ARCHITECTURAL ACCESS BOARD- HEARING PACKET

Name	Salem YMCA	Docket #	V 25 - 089		
Address	1 Sewall Street	Docket #	C -		
City	Salem	Hearing	8/24/2026		
Bldg Type		Time of hearing	11:00 AM		
Complaint's Name		Plans on file?			
Complaint ?	Variance ?	Request for continuance?			
Jurisdiction:	3.3.2	If the work performed amounts to 30% or more of the full and fair cash value of the building, the entire building is required to comply with 521 CMR.			
Building Permits:	Anticipated construction cost: \$3,500,000				
Assessed Value:	\$4,226,800

Exhibit: 1
V25-089
AAB 1-117

Petitioner seeks relief from: 26.6: A minimum clear floor area shall be provided on both sides of all doors and gates.

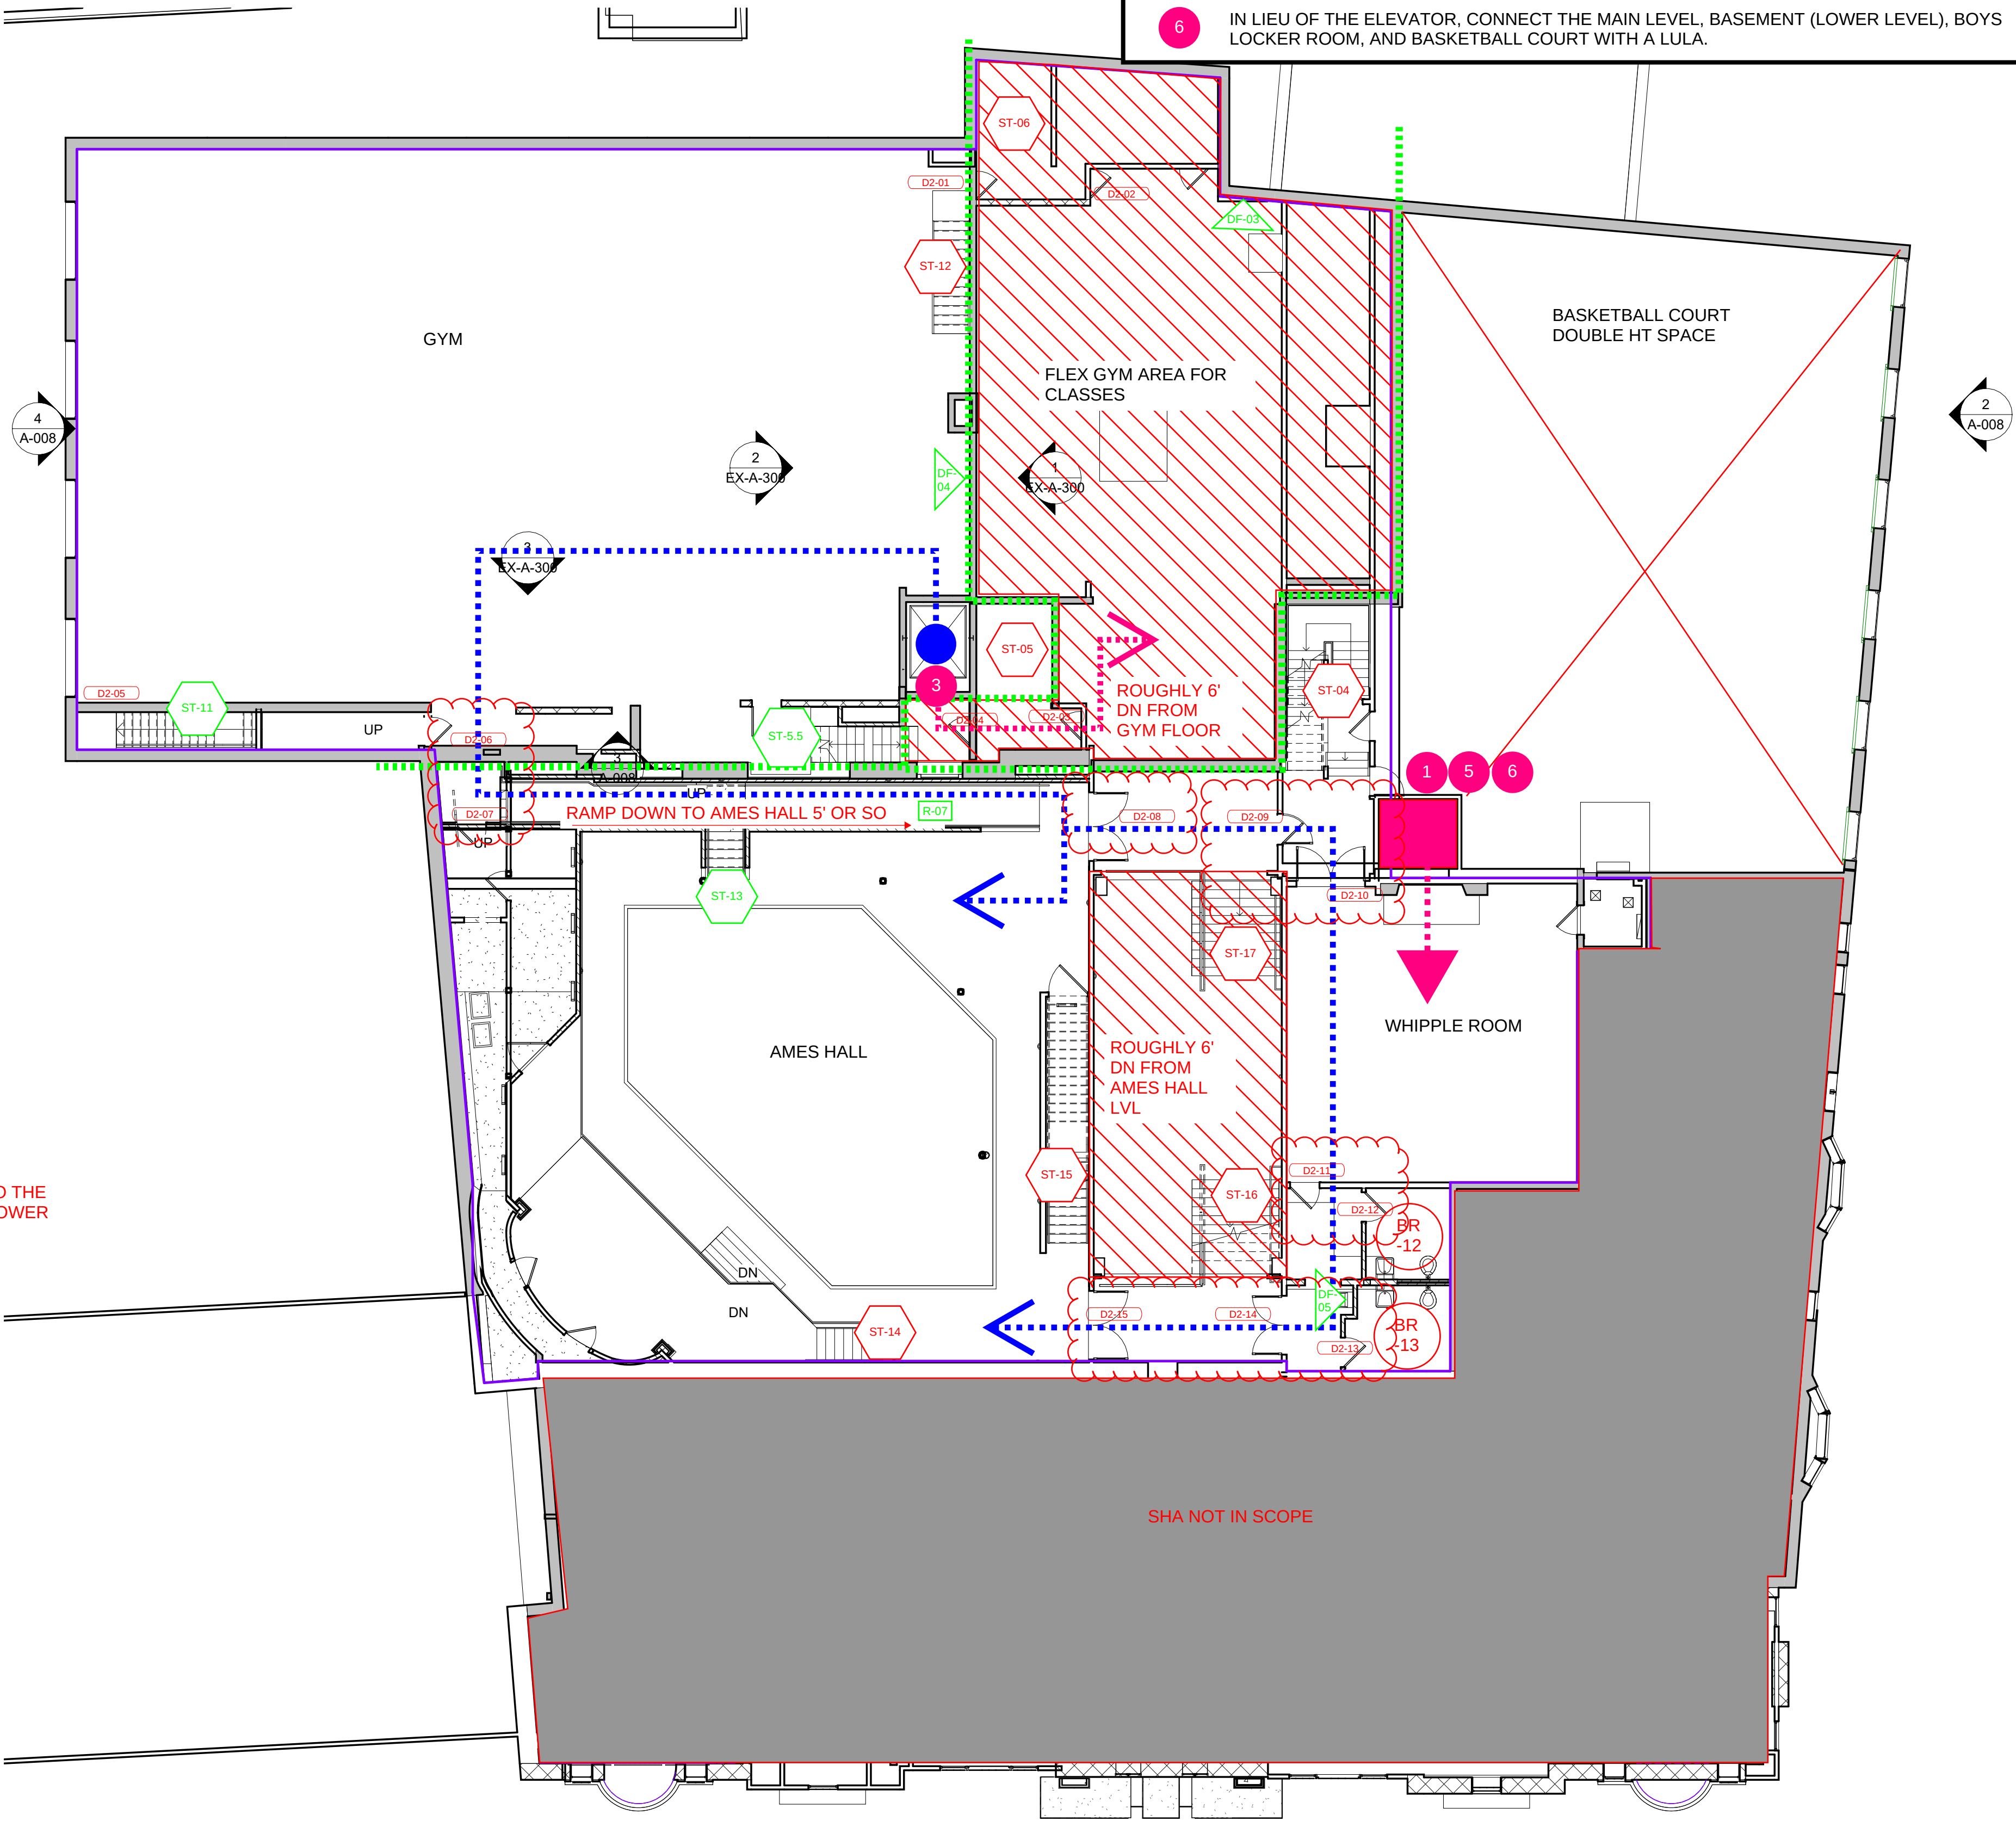
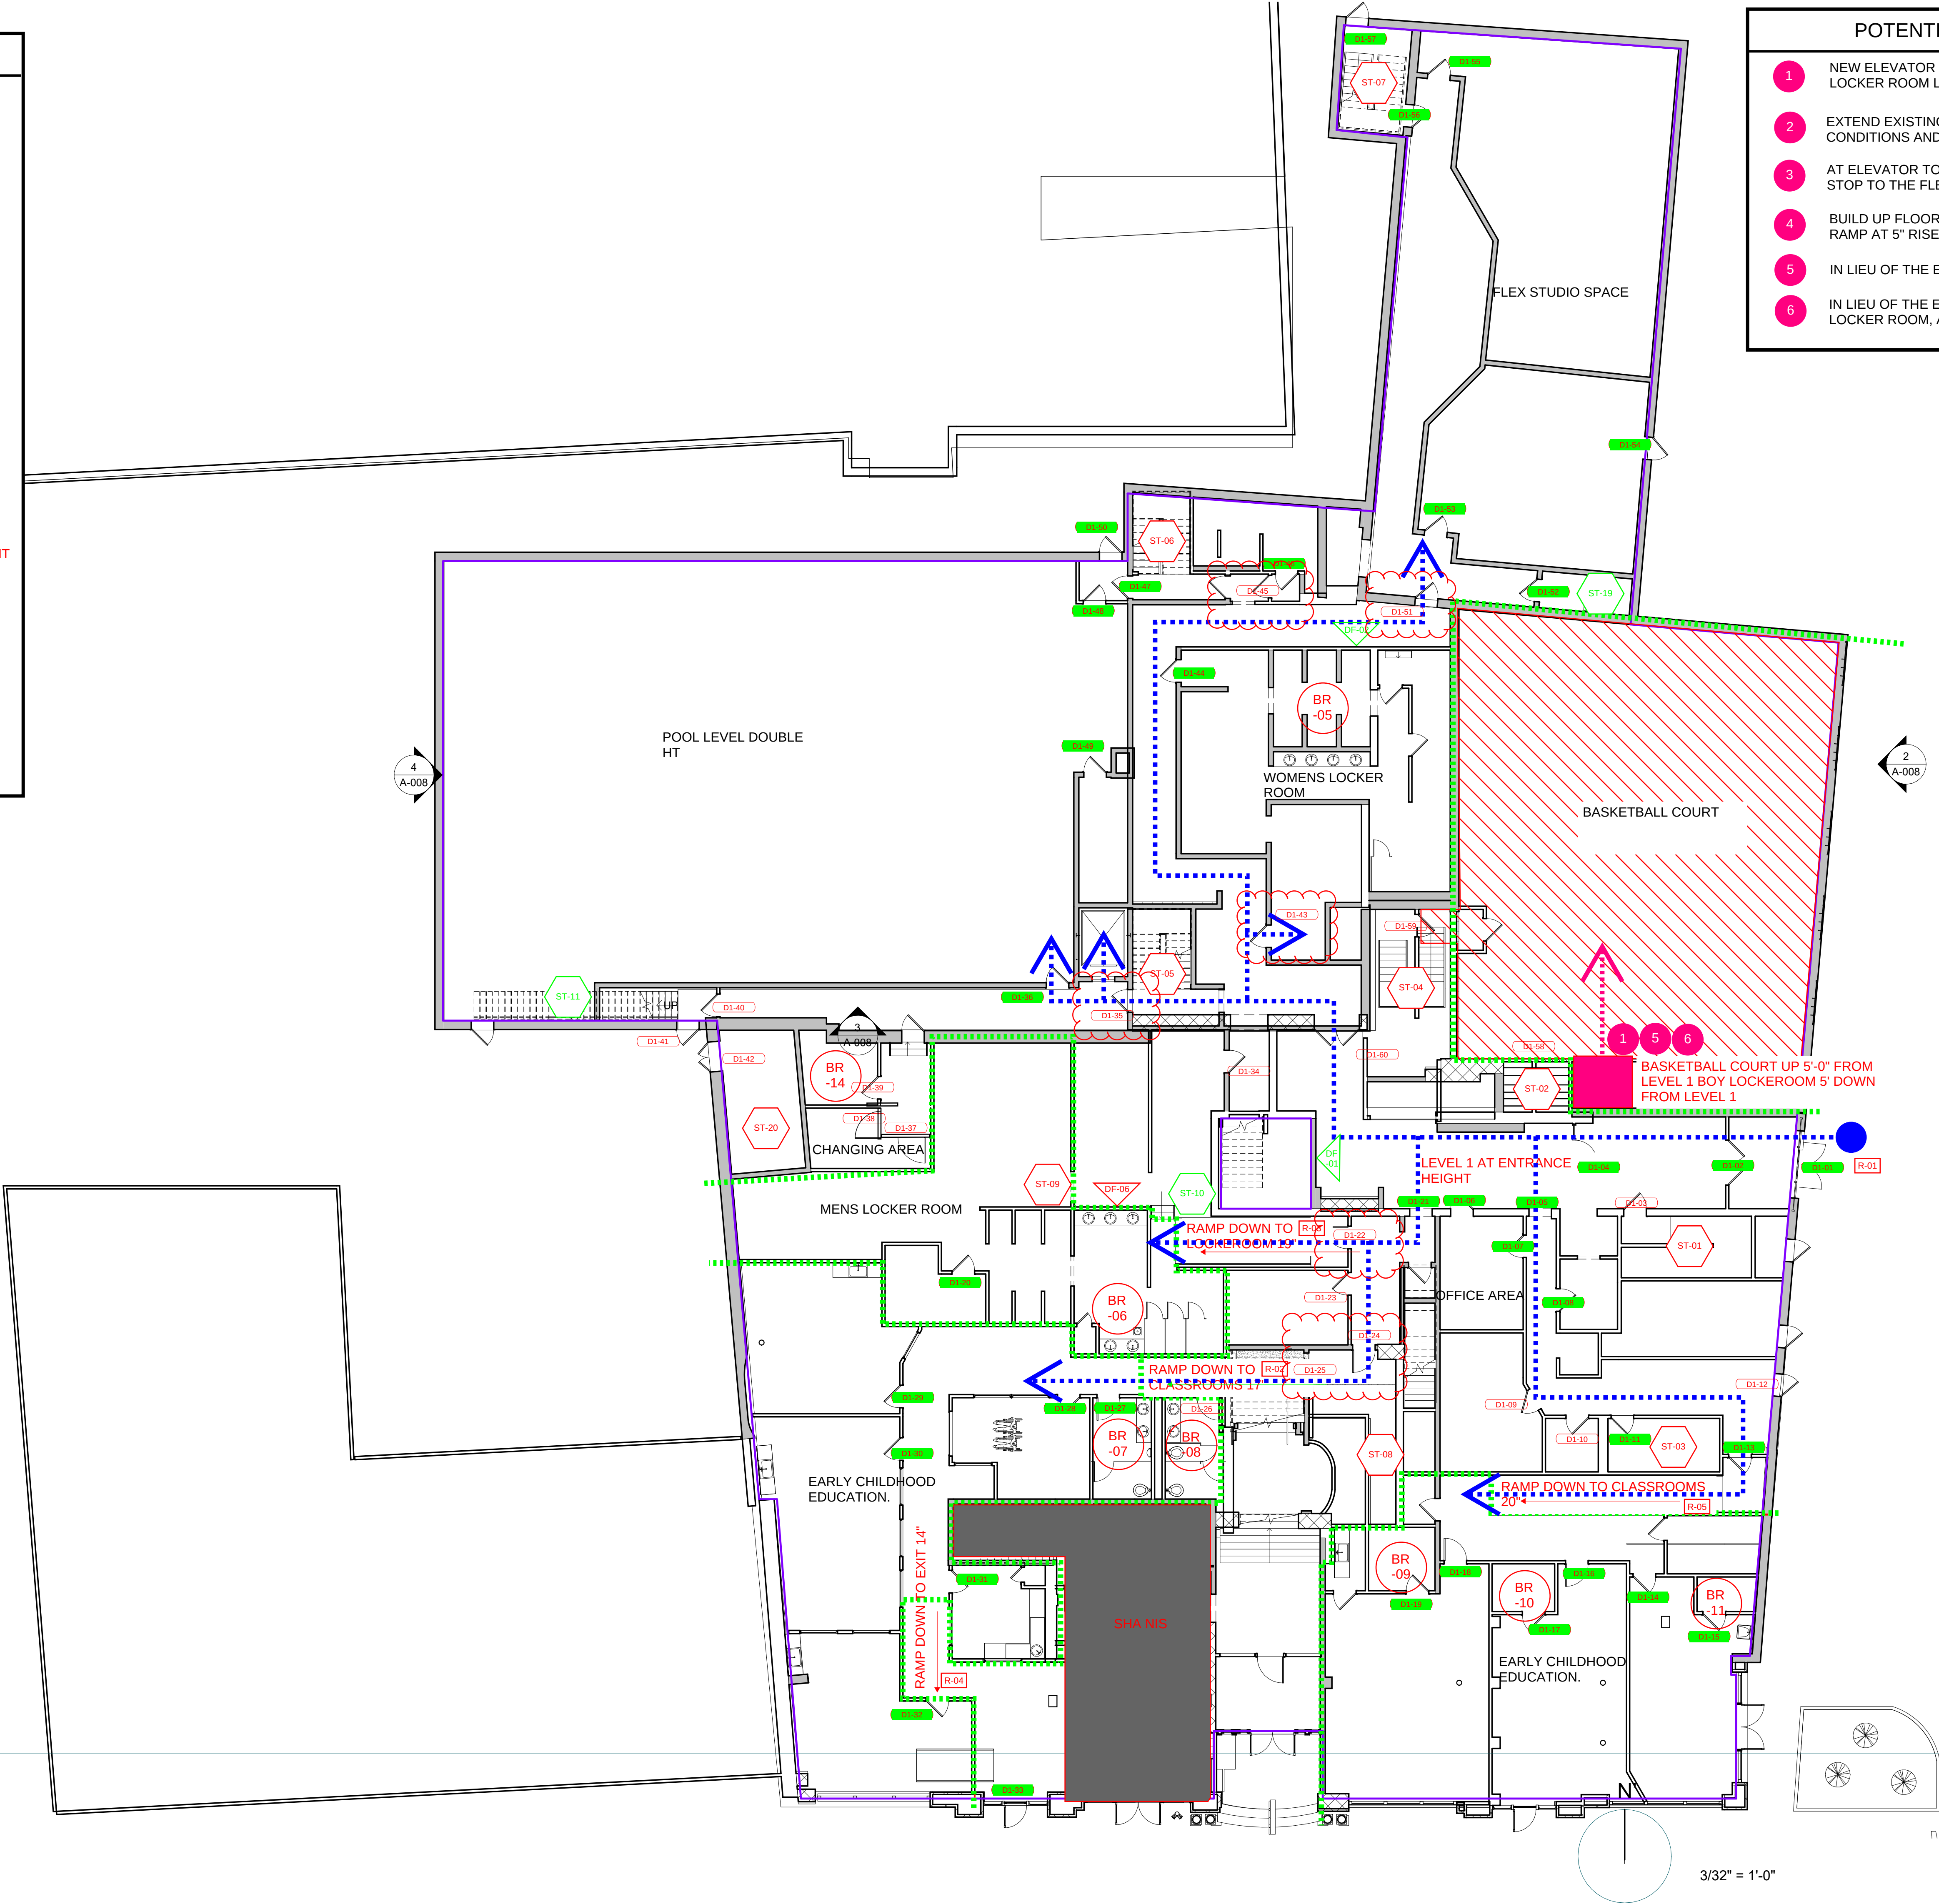
- to **CONTINUE** Petitioner's Request 2 for relief from 521 CMR 28.1 (elevator) and **ORDERS** Petitioner to provide the Board with: (1) test drawings for a permanent or portable lift; and, (2) the policy on moving programming to accessible spaces;

AT ELEVATOR TO BE UPGRADED WITH NEW ROOFTOP PROJECT, ADD ONE ELEVATOR STOP TO THE FLEX GYM AREA.

BUILD UP FLOOR AREA TO TYPICAL BASEMENT FLOOR HEIGHT (5"). INSTALL ONE RAMP AT 5" RISE.

Figure 1: Existing Stair Condition

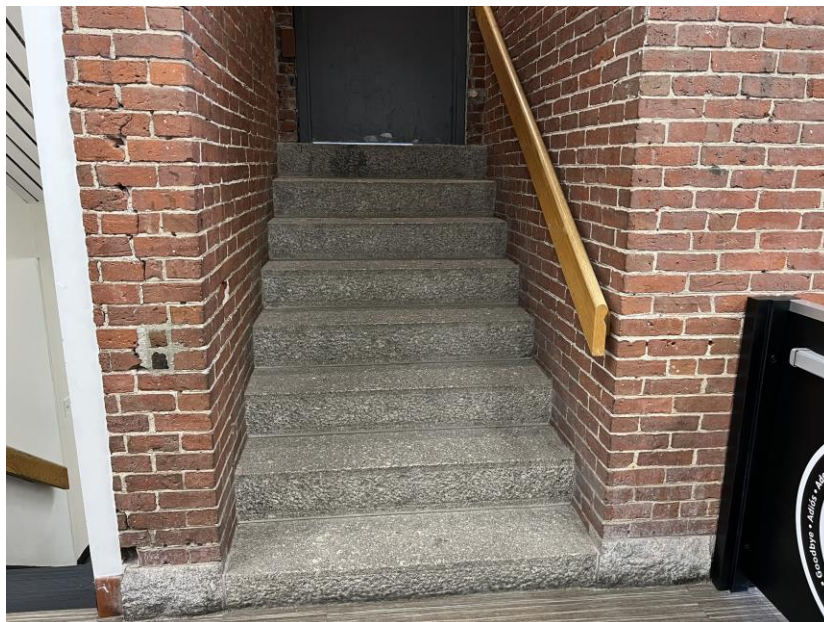
The existing stairs from Level 1 to the basketball court has one tread (bottom tread) that is not the same height as the other treads (see figure below).
